**Flood Control Project Maintenance
Levee Inspections**
LMA District Cover Sheet
Spring 2020 Levee Inspection Results

Yolo County Service Area 6

Levee Inspection Report By Mile - Spring 2020

Waterway	Bank	Unit Miles	Inspection Start/End	Inspector
Unit No. 01 Right Bank of Sacramento River at Knights Landing	Right	5.87	03/19/2020 03/19/2020	Zach Jojola

Photo 1 of 3 : UCIP_SP_2020_52729_58451.jpg

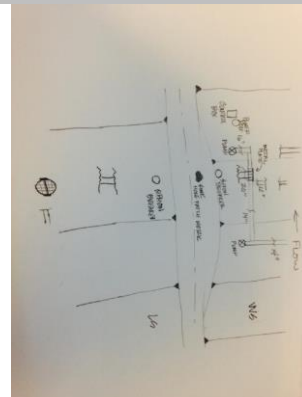
DS_ID:19531
FS_ID:52729
EP_NO: 9408
Repair Type: Urgent
Crossing Status: Found
UCIP Comments: 07/17/2018 No change from previous inspection. Patch repair of pavement on levee crown is in the same condition. Good candidate for internal inspection. (O.Yakimov-DWR UCIP)10/24/2017 Received updated photos from DWR levee inspector, Z. Jojola, and the photos show some depression along LS slope. Road patch repair is still visible on levee road, recommend an internal integrity inspection of pipe to determine the condition through the levee and slopes. (DWR UCIP - O. Magana) 07/13/2016 Same as last inspection. Sink hole repair visible on levee road. Recommend contacting owner to determine if an internal integrity inspection of the pipe was completed to confirm sink hole was not the cause of the damage to road. If no internal integrity inspection was completed during road repair, recommend an internal integrity inspection be completed at this location based on the sink hole that developed along pipe alignment and based on age of pipe. (DWR UCIP - omagana)03/04/2014 Signs of sink hole repair on levee crown. Owner will need to contact CVFPB to address sink hole repair. (DWR UCIP - omagana)

FIELD_STRUCT_DESC: 20-inch steel irrigation discharge pipe through the levee, 4.7 feet below the crown. Two slant pumps on the waterside (WS) slope. Steel protective housing unit on each shoulder. Ramp on the landside (LS) slope. (Retention of a 20-inch pipe through the levee with two pumps on the WS berm authorized under Automatic Board Order (ABO) issued as Permit No. 9408, 1974 - Davidella, Grace, and Florence Hershey, Estates, care of LaBorde and Hoover). [Additional Reference(s): DWR Levee Log, 2005].
FS Date: 7/17/2018 11:54:53 AM
